Re: Colorado Department of Public Health and Environment's Clean Air Act (CAA) Renewal of Title V Permit 95OPAD108 Suncor Energy, Inc. Plant 2 (East Plant)

Pursuant to 40 C.F.R. §§ 70.8(d), 70.12, the Elyria and Swansea Neighborhood Association, Cultivando, Colorado Latino Forum, GreenLatinos, Center for Biological Diversity, and Sierra Club ("Petitioners") hereby petition the United States Environmental Protection Agency ("EPA") to object to the Colorado Department of Public Health and Environment's ("CDPHE") renewal Title V Permit No. 95OPAD108 for Plant 2 of the Suncor Energy, Inc. petroleum refinery ("East Plant") located at 5800 Brighton Blvd., Commerce City, CO 80022, Adams County.

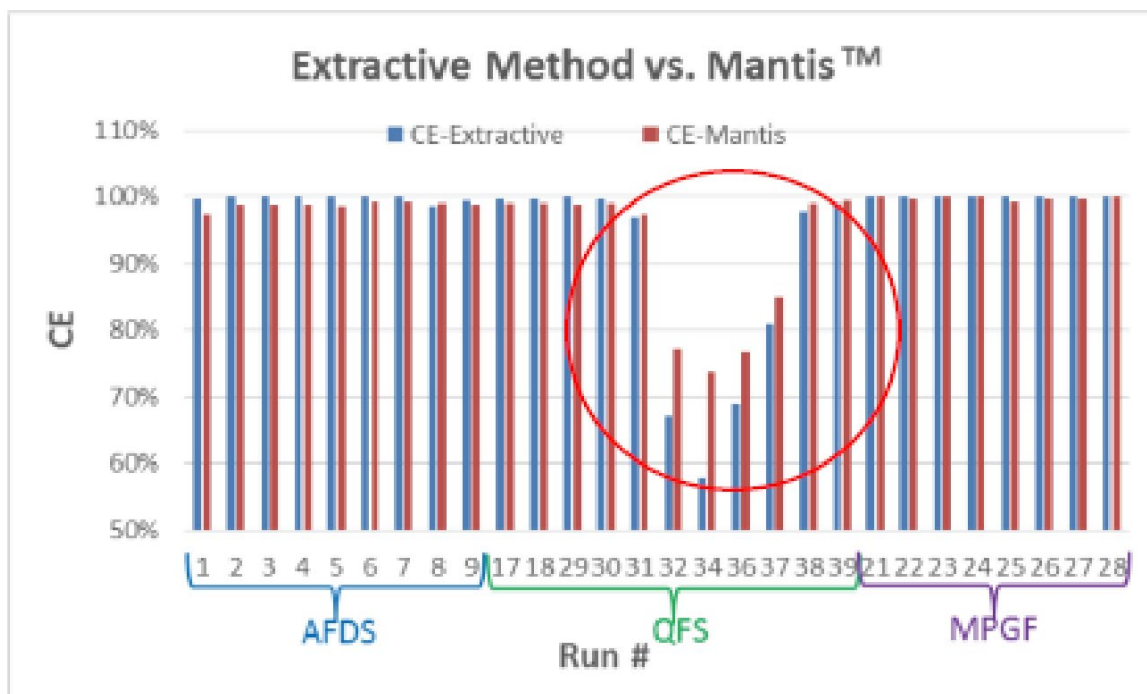
The following chart from a study of flare control efficiency demonstrates the problem:⁷⁶

As the chart shows, even under controlled conditions a flare’s control efficiency (“CE”), and by extension destruction efficiency, can drop to very low values (55% or so in this case). So, the Division’s simple assumption that destruction efficiencies will be 98%, Proposed Permit § II, Cond. 8.1, is not realistic and the evidence establishes that achieving such rates is not consistently achievable, such as with rapidly varying flow rates and waste gas compositions.
